AMENDMENT OF SOLICITATION/MODIFICATION OF CONTRACT				BPA NO.		1. CONTRACT ID CODE		PAGE 1		OF PAGES 2									
2. AMENDMENT/MODIFICATION NUMBER A00001				3. EFFECTIVE DATE 02-23-2017		4. REQUISITION/PURCHASE REQ. NUMBER				5. PROJECT NUMBER (if applicable) 849-M&R17-01									
6. ISSUED BY Department of Veterans Affairs NCA Contracting Service 75 Barrett Heights Rd. Suite 309 Stafford VA 22556				CODE 43C1		7. ADMINISTERED BY (If other than Item 6) Department of Veterans Affairs NCA Contracting Service 75 Barrett Heights Rd. Suite 309 Stafford VA 22556				CODE 43C1									
8. NAME AND ADDRESS OF CONTRACTOR (Number, street, county, State and ZIP Code) To all Offerors/Bidders						(X)		9A. AMENDMENT OF SOLICITATION NUMBER VA786-17-Q-0218											
								9B. DATED (SEE ITEM 11)											
								10A. MODIFICATION OF CONTRACT/ORDER NUMBER											
								10B. DATED (SEE ITEM 13)											
CODE						FACILITY CODE													
11. THIS ITEM ONLY APPLIES TO AMENDMENTS OF SOLICITATIONS																			
<input checked="" type="checkbox"/> The above numbered solicitation is amended as set forth in Item 14. The hour and date specified for receipt of Offers <input type="checkbox"/

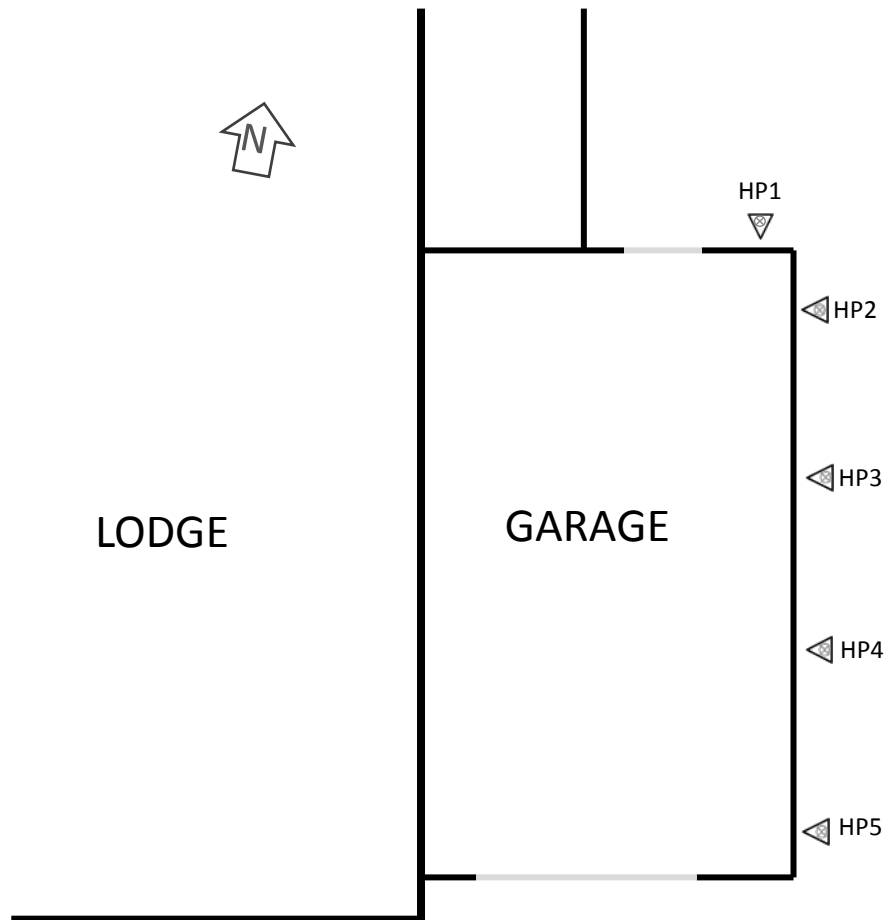
The Helical Piers (HP) locations shown represent the minimum number required. The actual number and exact locations will be based on the geometric configuration of the piers, strength of steel helices, anticipated subsurface conditions, and torque applied. This information is to be provided by the contractor in a submitted to be approved by the Contracting Officer Representative (COR).
